CHRYSLER RWD TRANSMISSIONS IMPROVED LINE RISE & THROTTLE RESPONSE

Figure 1

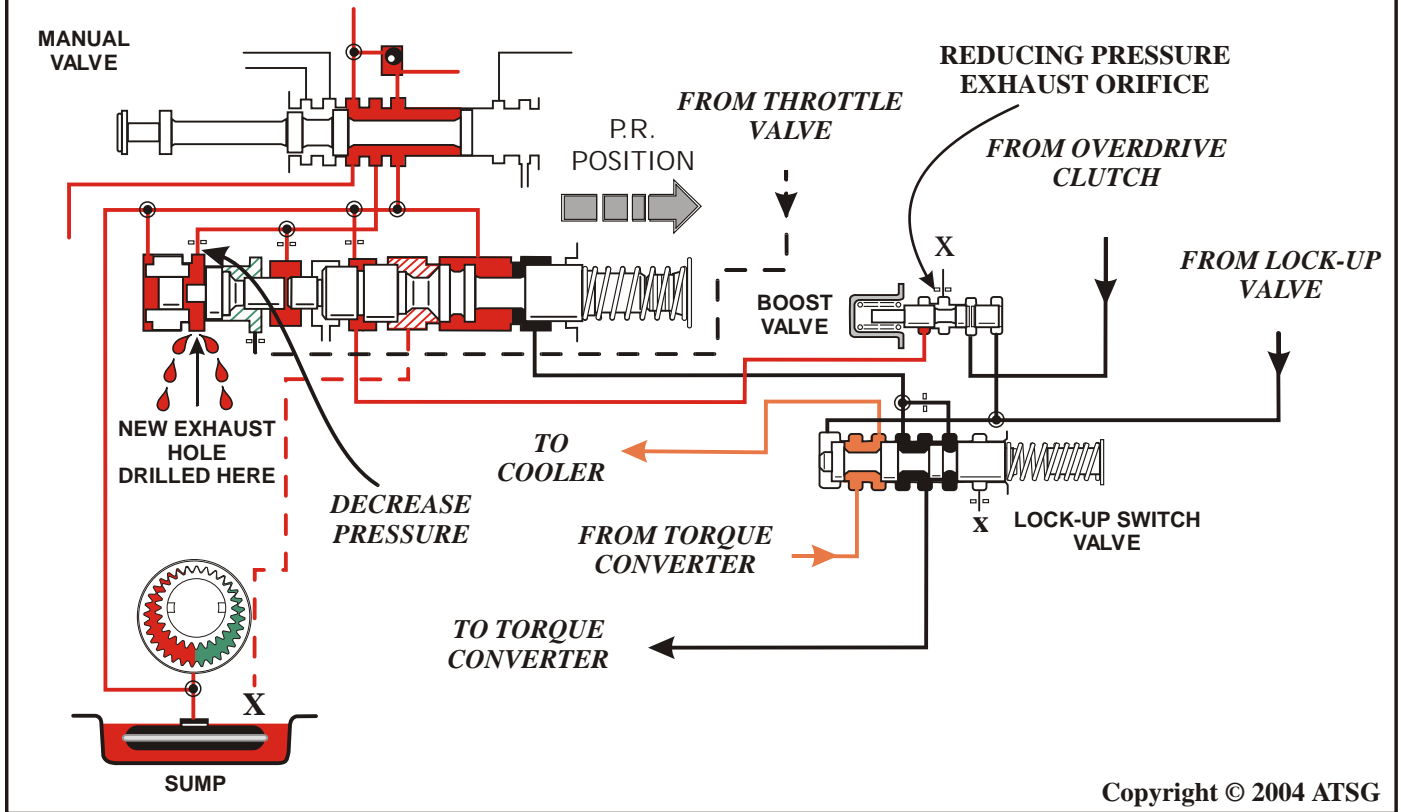
CAUSE: Decrease pressure supplied to the pressure regulator valve throttle plug, which is used to prevent line pressure from exceeding approximately 100 to 120 psi at wide open throttle (See Figure 1).

Figure 2

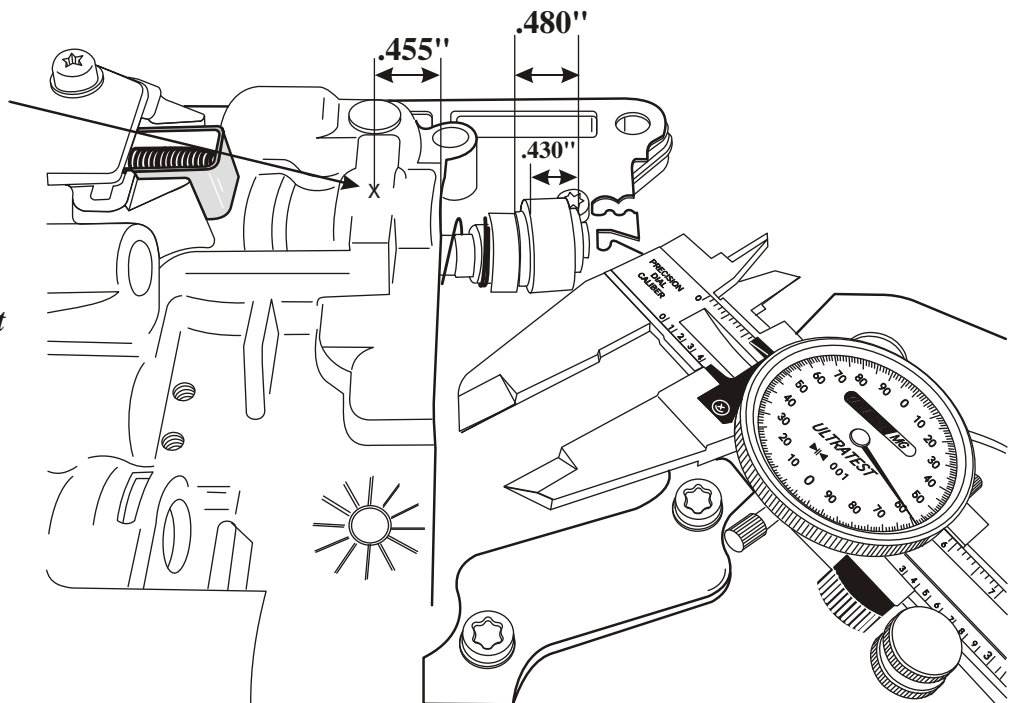
COMPLAINT: It is commonly known that line rise of RWD Chrysler transmissions, i.e. 904, 727, 500/618, all **“PRE”** 1996 RE units is sluggish and in many cases insufficient. This causes technicians to find themselves having to adjust the throttle rod/cable in an attempt to located a happy medium of shift feel and shift timing. Many times the vehicle is delivered with out really achieving the desired shift characteristics.

CORRECTION: Drill a .040" exhaust hole through the exterior casting into the decrease pressure circuit by following the “example” steps below and illustrated in Figure 2. A controlled venting of this oil will allow a more rapid line rise response to throttle opening, improving the shift characteristics of the transmission. It also will allow a more desirable top end line pressure reading as well as a slight increase in the converter clutch apply pressure.

Step 1. Measure the overall length of the plug (.480") as seen with the example in Figure 2.

Step 2. Measure the length of the plug minus one shoulder (.430") as seen with the example in Figure 2.

Step 3. The difference between the two readings is .050". By dividing that number in half (.025") and adding it to the figure acquired in step 2 (.430"), the depth from the edge of the bore to the decrease circuit can be marked for drilling on the top side of casting, approximately .455", also shown in Figure 2.

Measure approximately .455" in from the edge of the valve body over the pressure regulator valve throttle plug bore and drill a .040" exhaust hole through the valve body casting.
